{ Denotes changes to ADD. 98 - 10/15/76 CO ADD. 98 - 5/5/77

H-1 VIADUCT (WB)

INDEX TO DRAWINGS
ESTIMATED QUANTITIES

KEEHI INTERCHANGE
F.A.I. PROJ. NO. I-HI-1 (130): 17

SIGN POST SHAFT - ANCHOR BOLT DETAIL

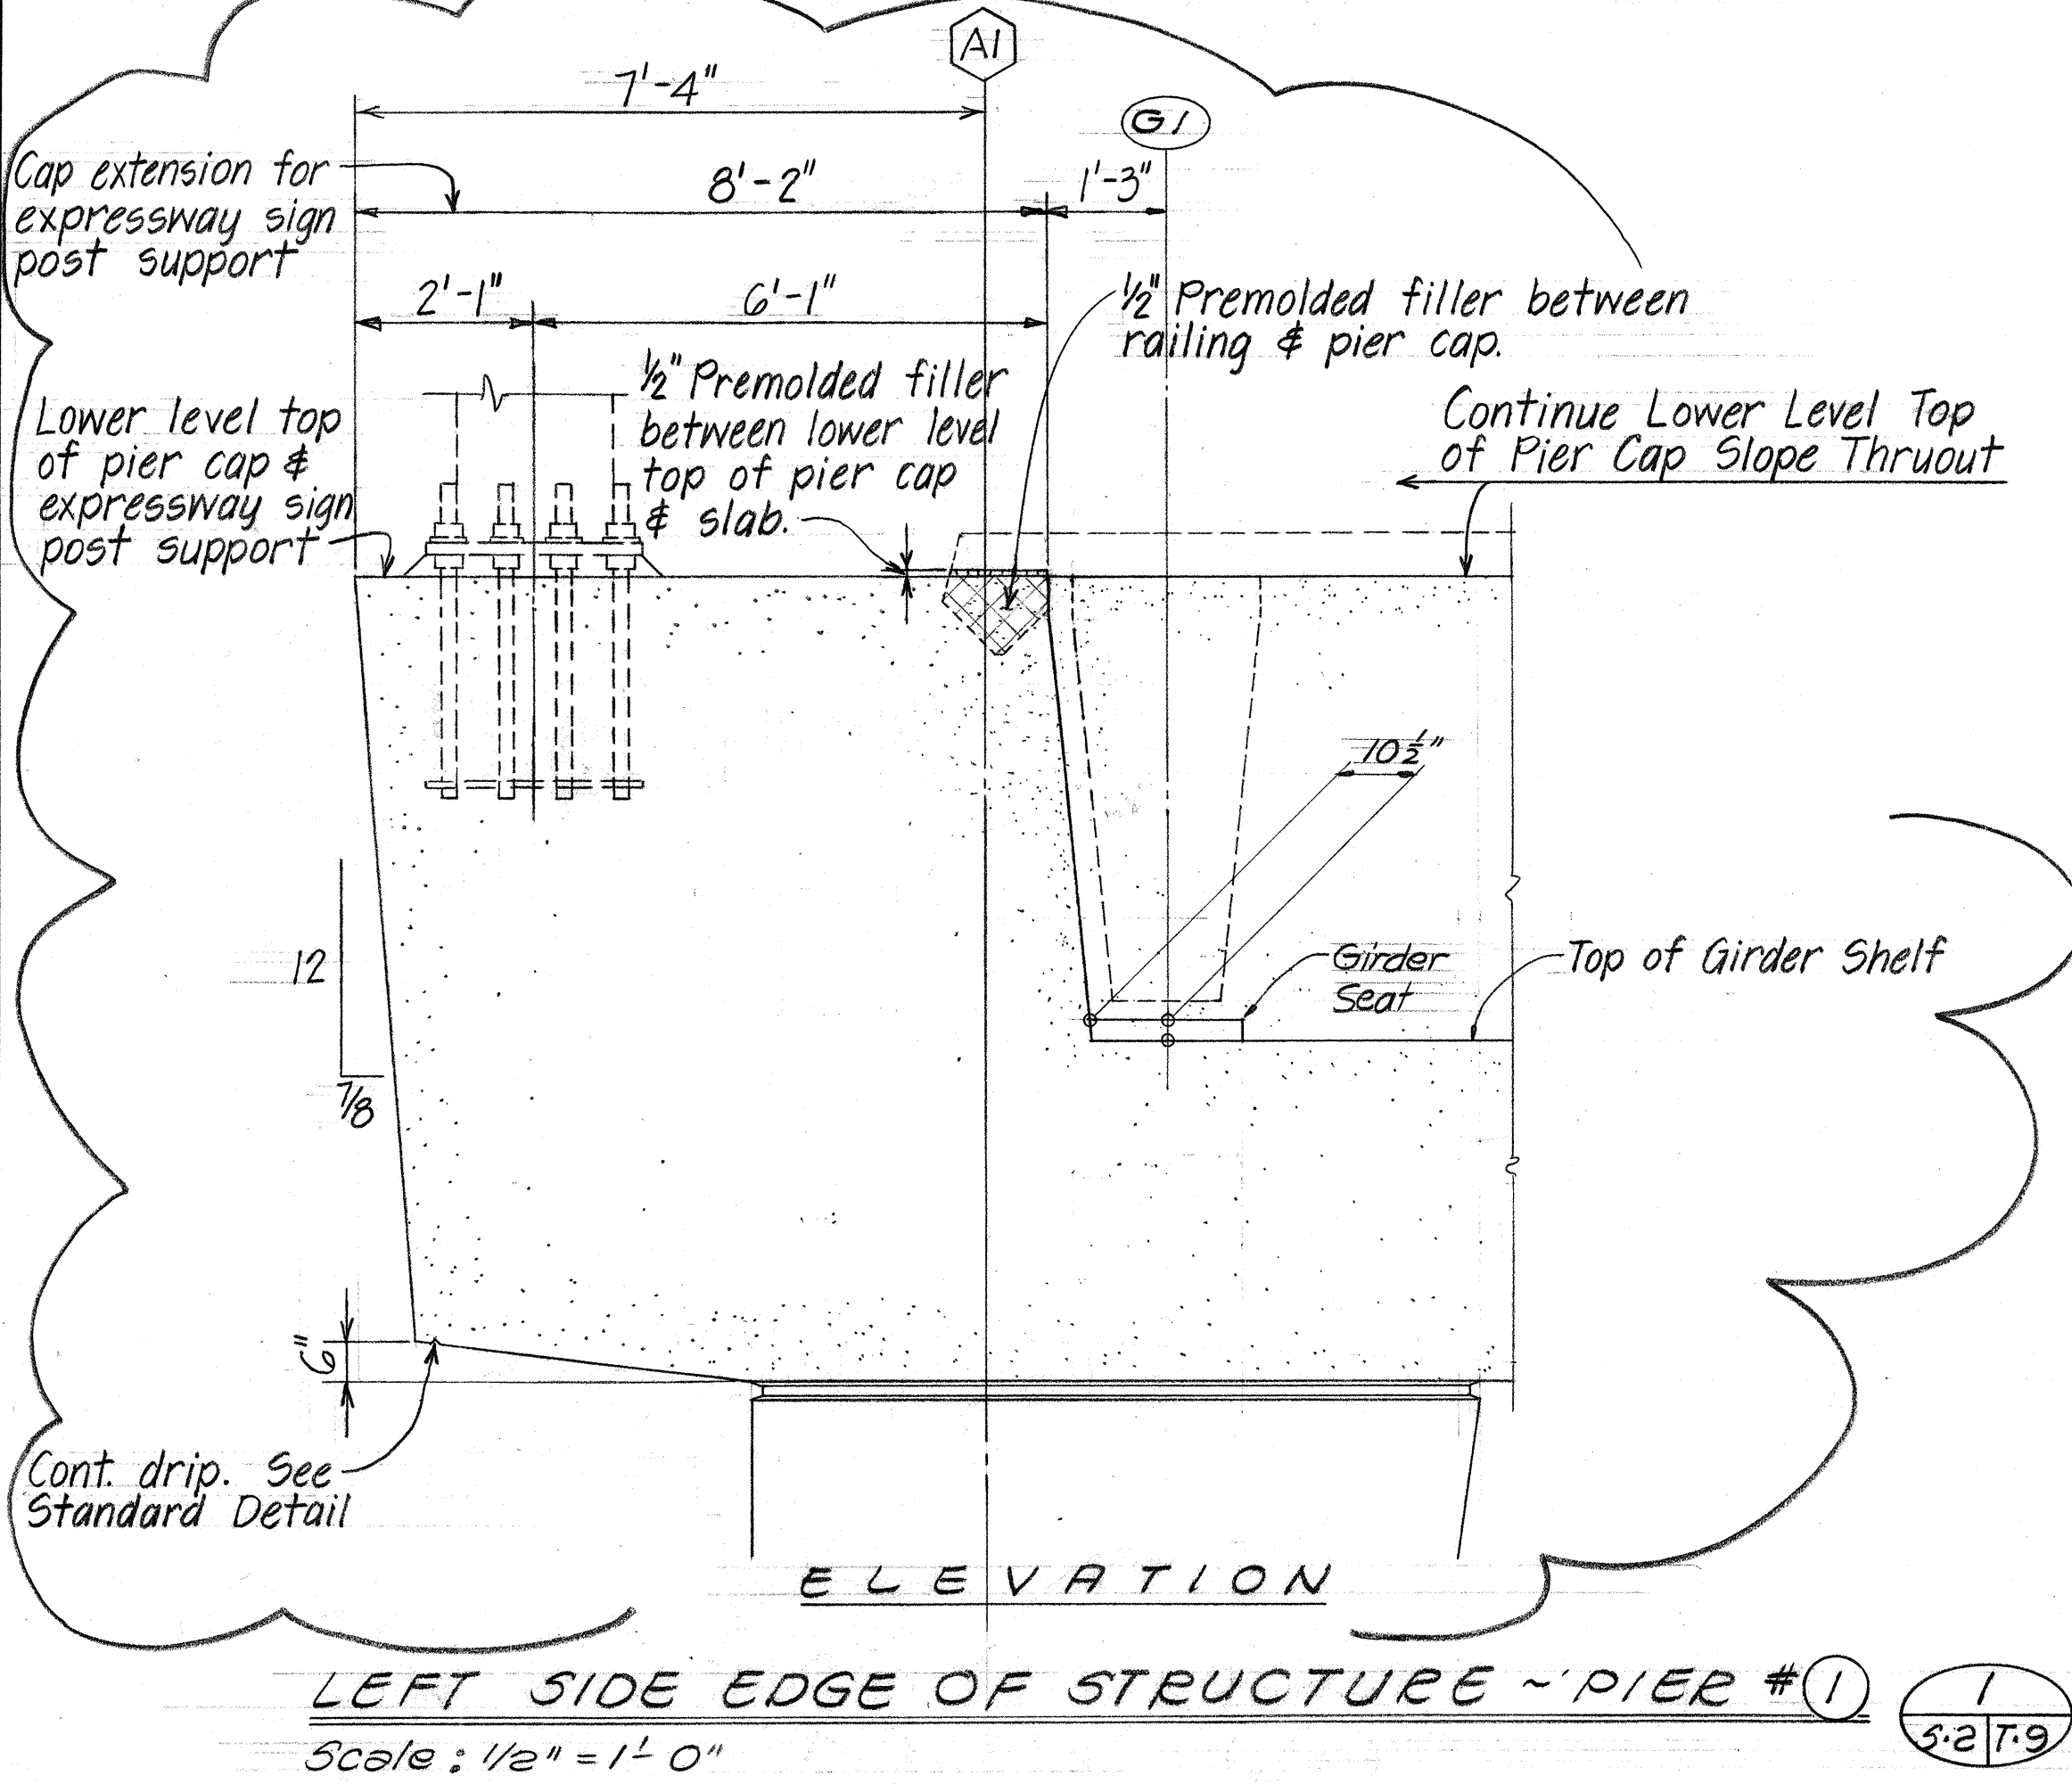
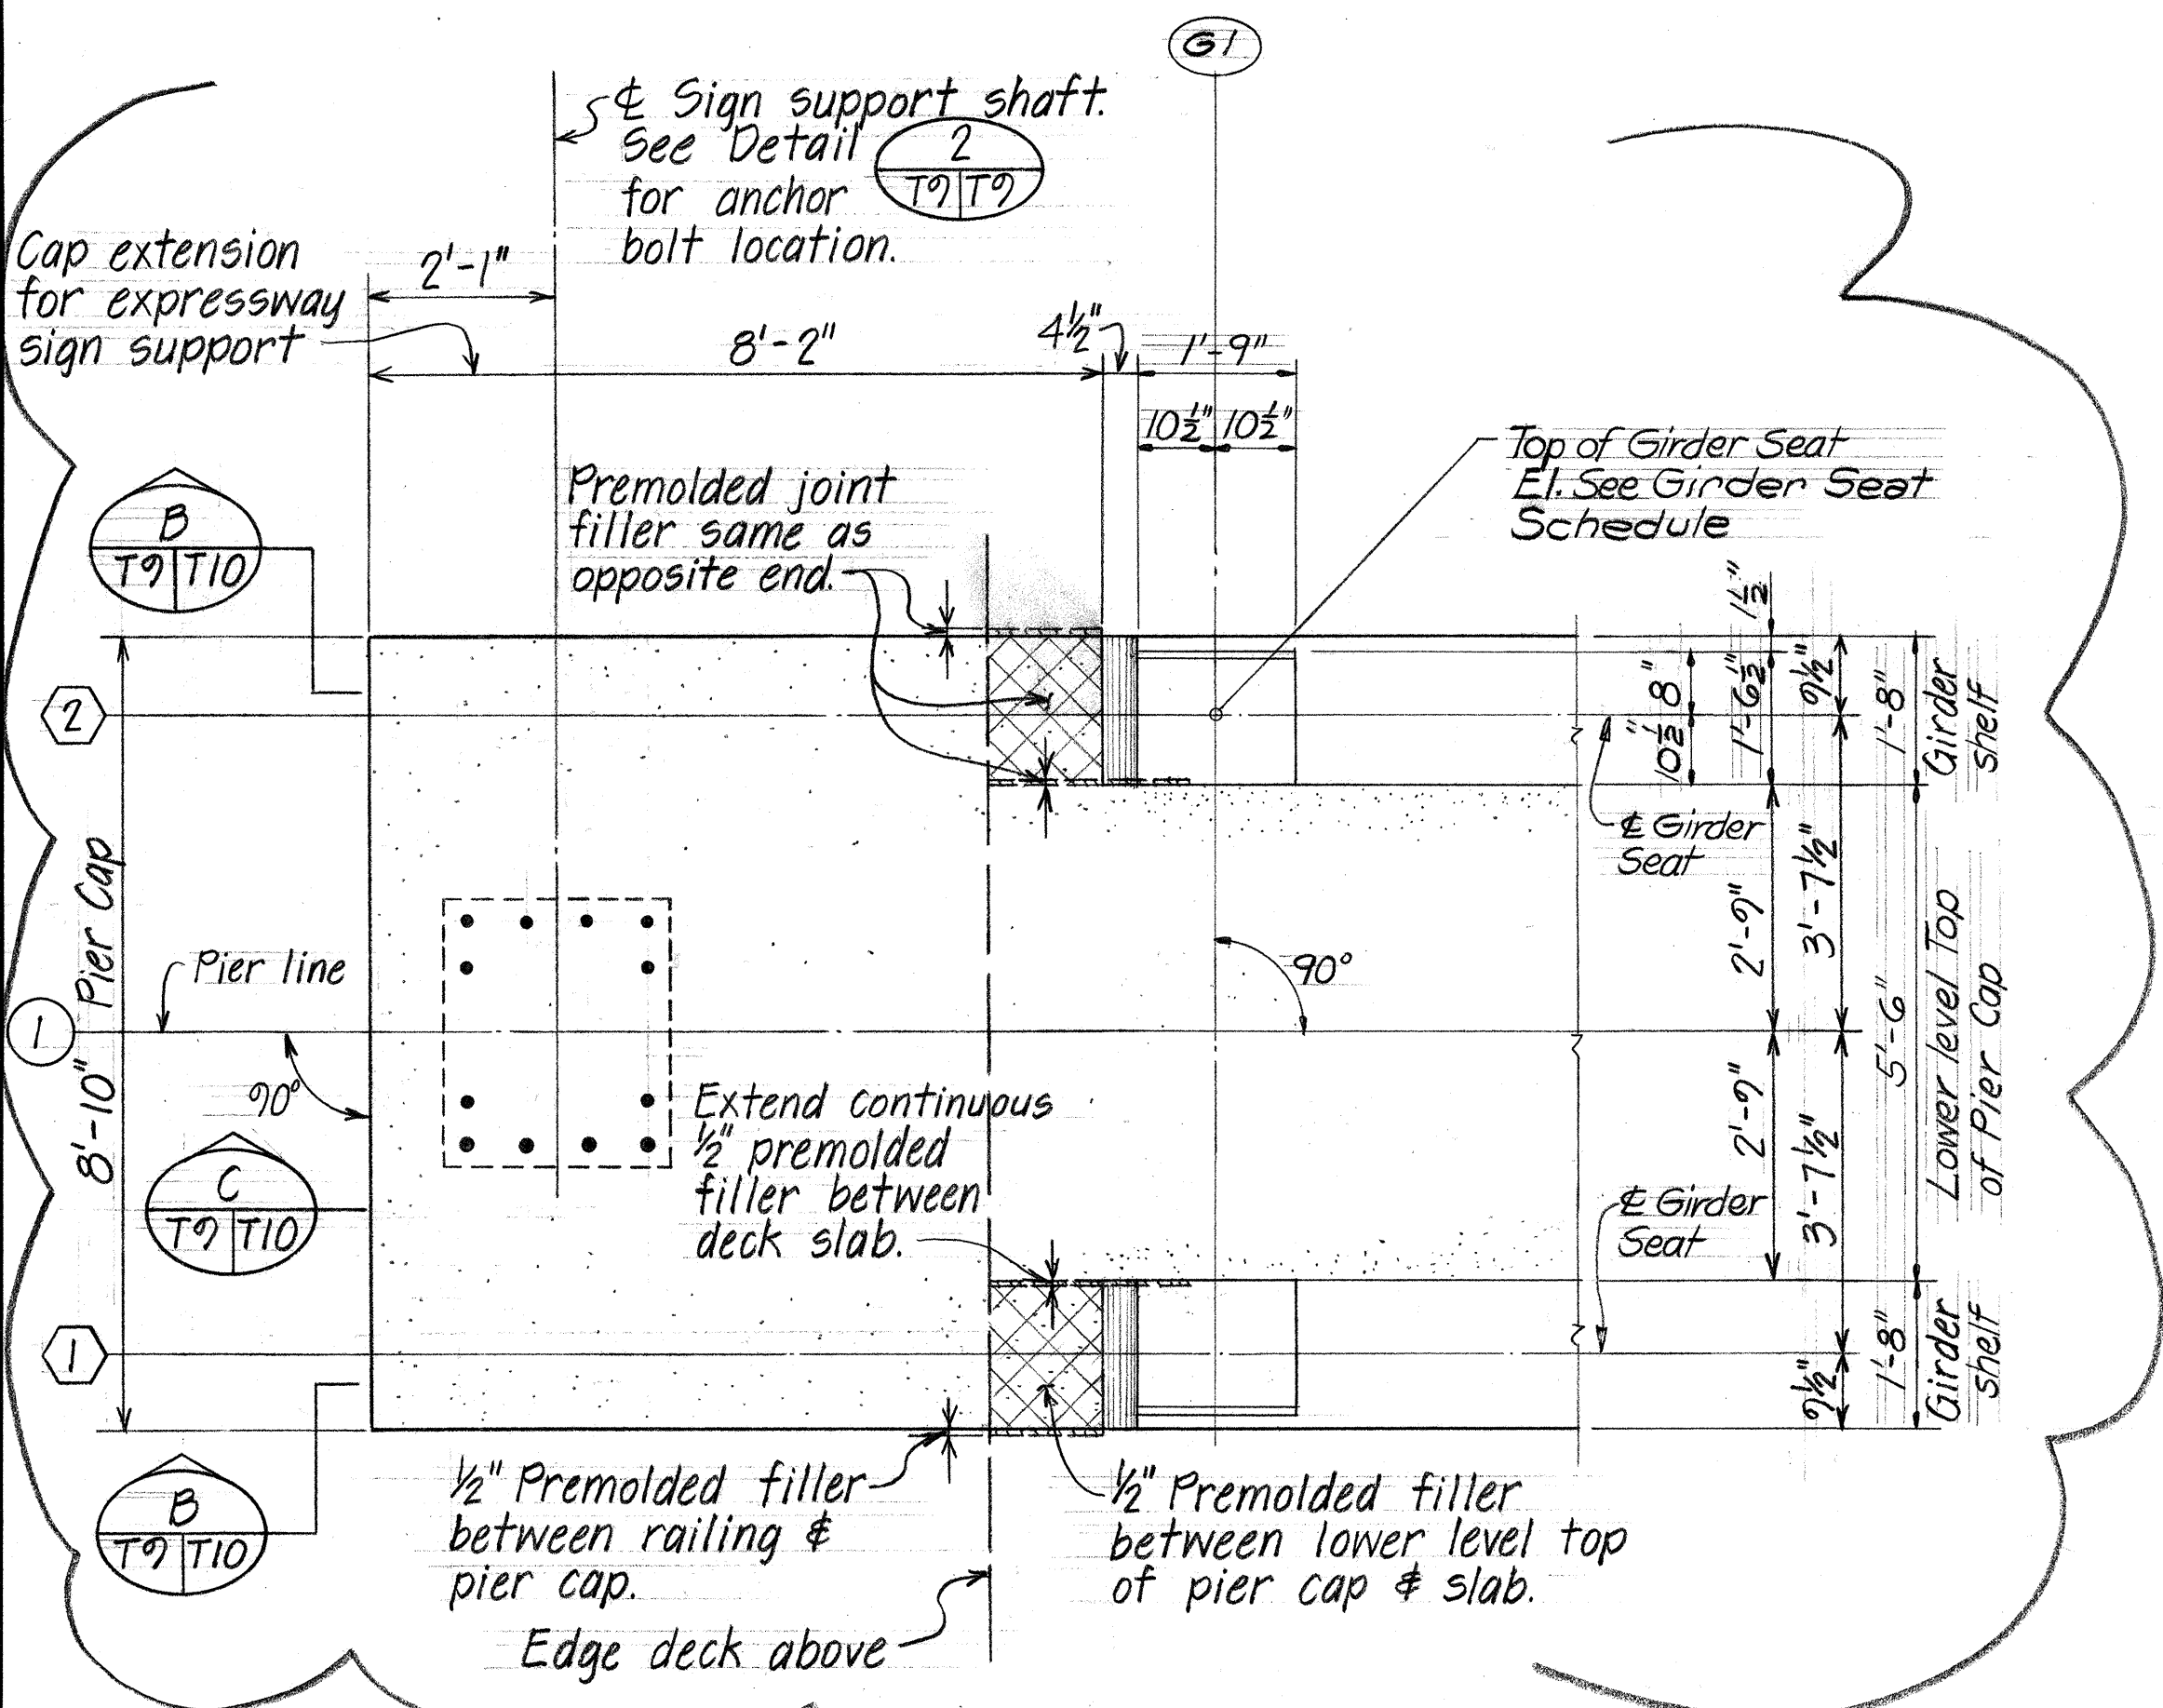
5/5/77	Revised Pier No. 1 cap extension and sign post shaft location.
DATE	REVISION
STATE OF HAWAII DEPARTMENT OF TRANSPORTATION HIGHWAYS DIVISION TYPICAL DETAILS PIER 1 FRAME SIGN SUPPORT DETAILS	
KEEHI INTERCHANGE F.A.I. PROJ. NO. 1-HI-1(130):17	
Scale: As shown.	Date: Aug. 16, 1976
SHEET NO. T9 OF 20 SHEETS
